LIGO- T1100113-v2

Mitigation Of Wide Angle Scatter From Hr Surface Of The  
Test Mass with the Arm Cavity Baffle

Michael Smith

**Figure 1: ACB with Wide Angle Extendable Top, Bottom, and Sides**

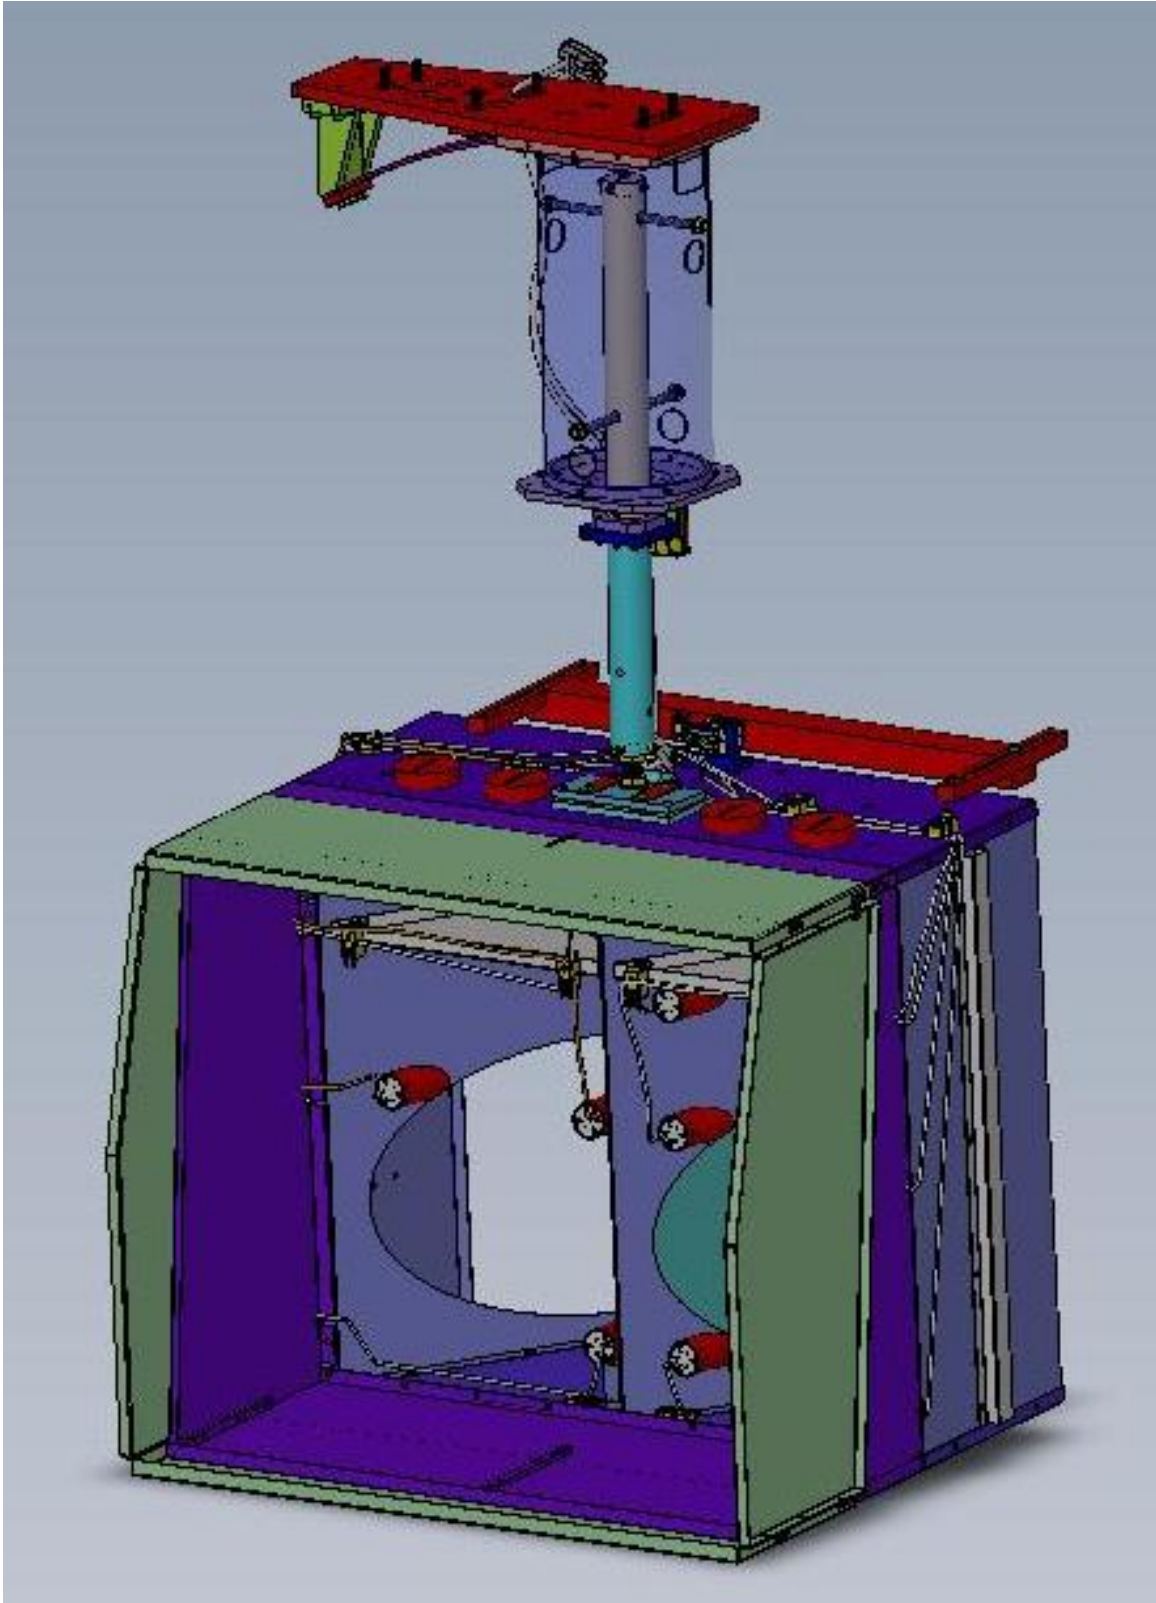
*1) You mention extend-able sides, need to see detailed layout of new design wrt each ETM / ITM? (i.e. in all chambers)*

The wide-angle box baffle structure is comprised of a fixed set of top and bottom shelves, and side walls that mount to the back of the arm cavity baffle; and a sliding extender box structure that fits over the fixed portion and is extended to bring the box structure as close as practicable to each TM suspension installation, as shown in Figure 2. The dimensions of the extended wide angle box for each of the TM installations are shown in [D0901376\\_AdLIGO\\_AOS\\_SLC\\_ARM\\_Cavity\\_Baffle\\_Final Assy-v2](#) ; see sheets 2, 3, 4, and 5.

4) *how does this addition affect your balance masses and counter masses (used to bring blade to correct position?) please provide detail of balance arm*

The counter balance mass for the extended baffle box extends beyond the front of the arm cavity baffle and can be placed at different locations on the extended bars to balance the different extensions of the baffle box, as shown in Figure 1.

**Figure 3: Removable Extender baffle**

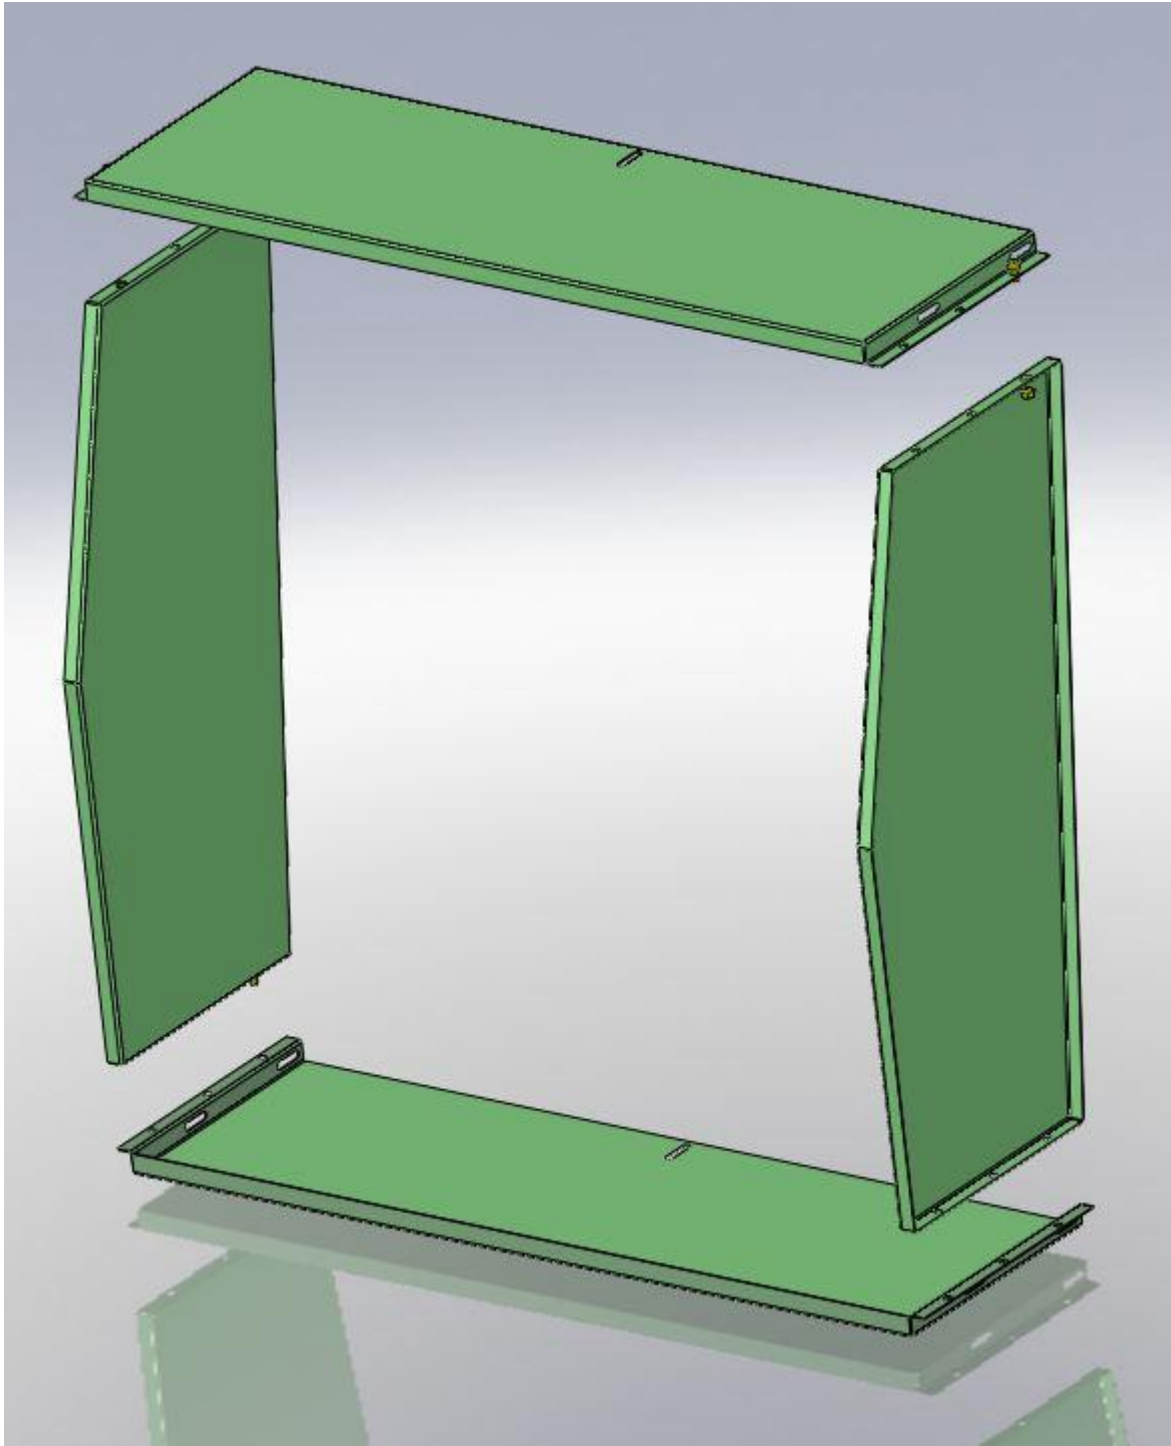
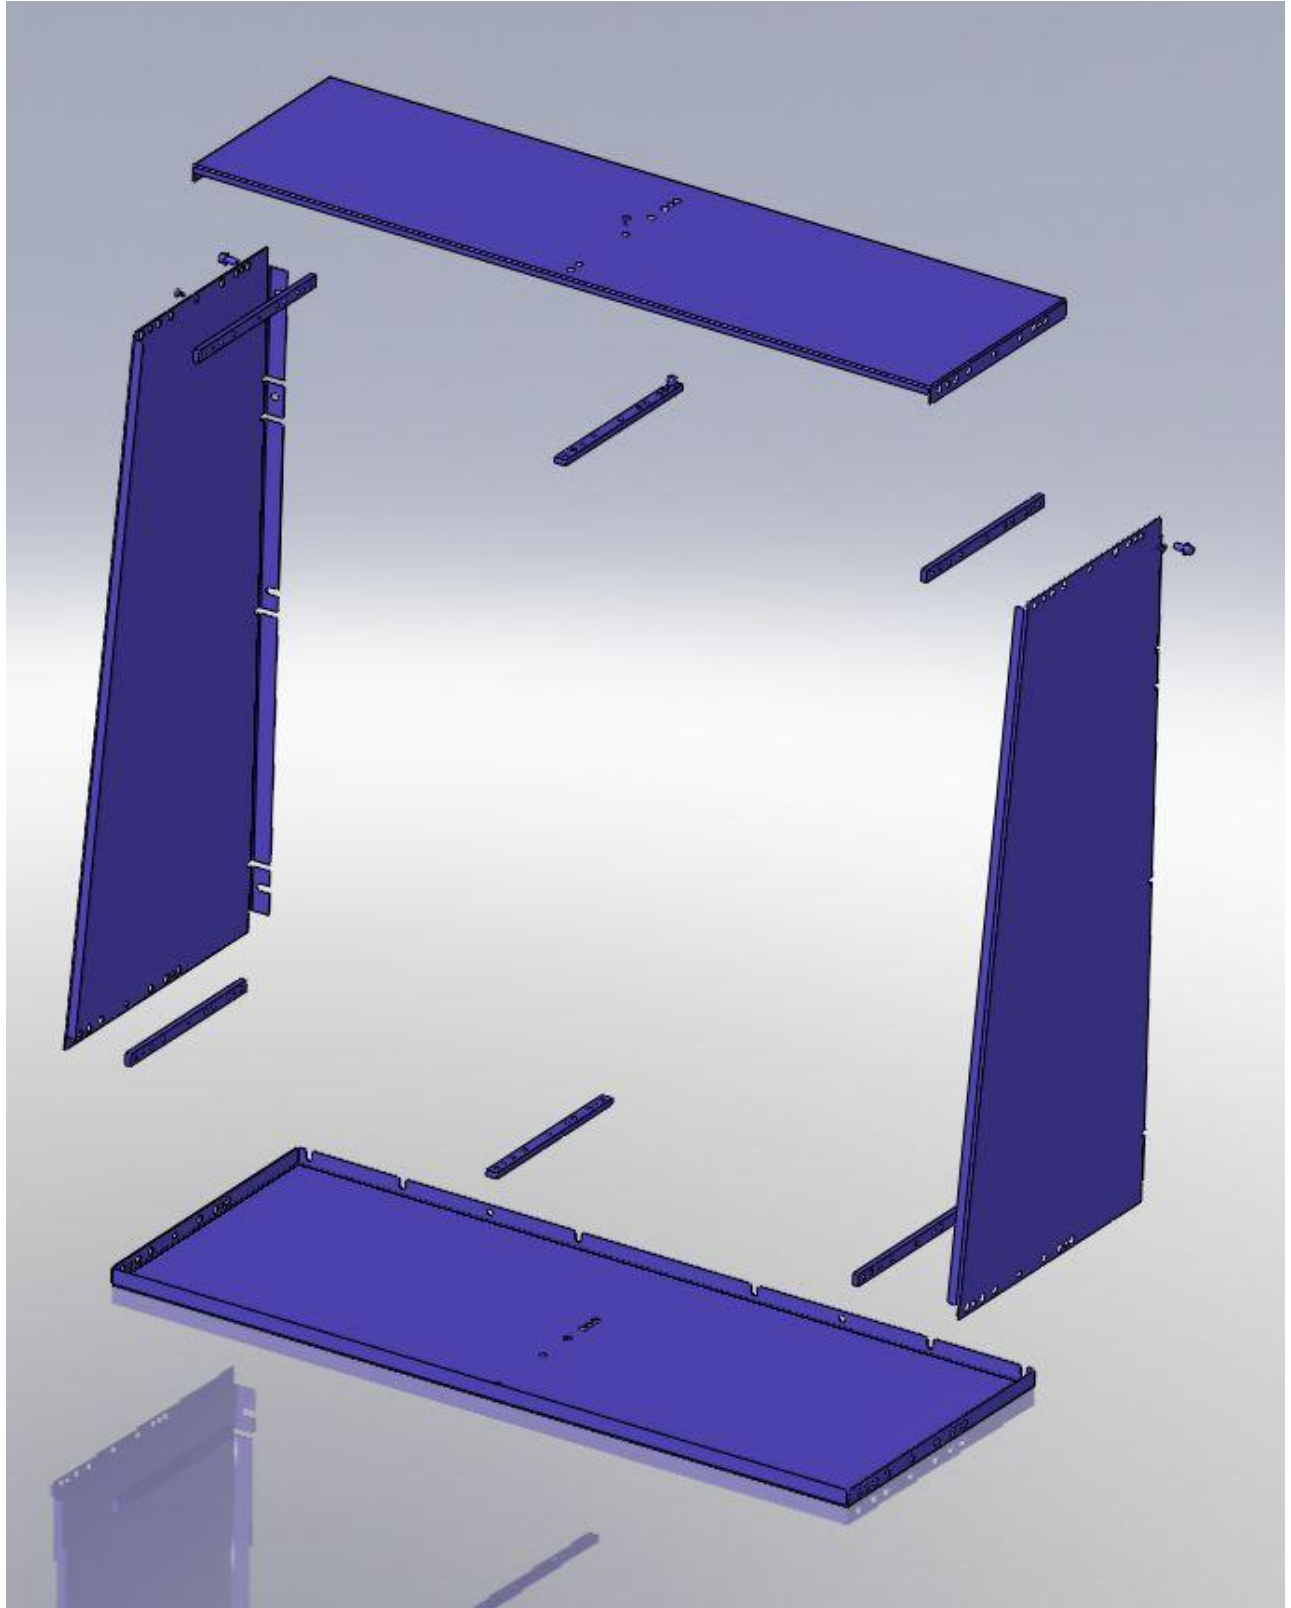
*2) Are removable side sections removed / replaced from the outside?*

The extender box and the fixed blue box can be disassembled from the main arm cavity baffle while it is installed inside the BSC chamber, as shown in Figure 3 and Figure 4.

**Figure 5: Captured plate with tapped holes**

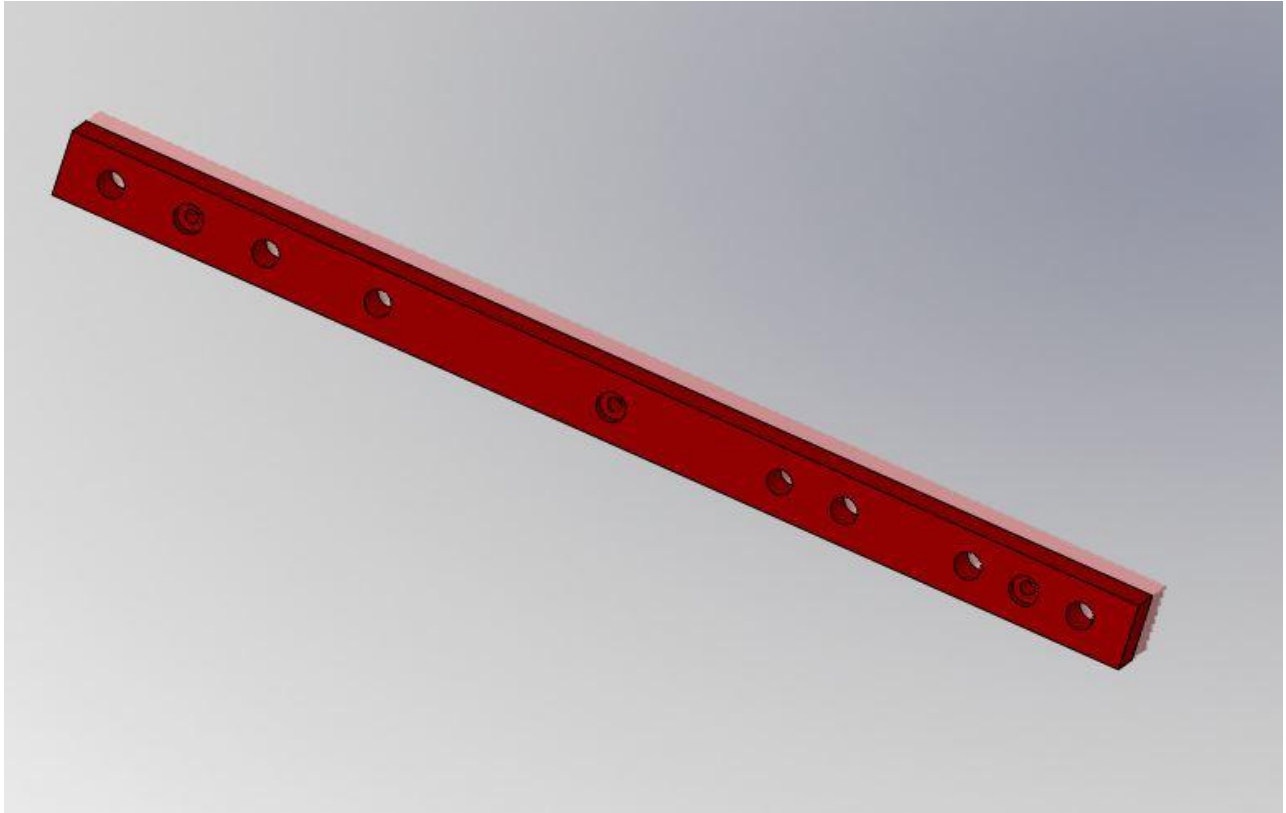
3) *What are used in place of tapped holes in the sheet metal to connect the sections?*  
The extender box sides, shown in green, are attached to the fixed blue box sides by means of the captured plate with tapped holes, shown in Figure 5 .
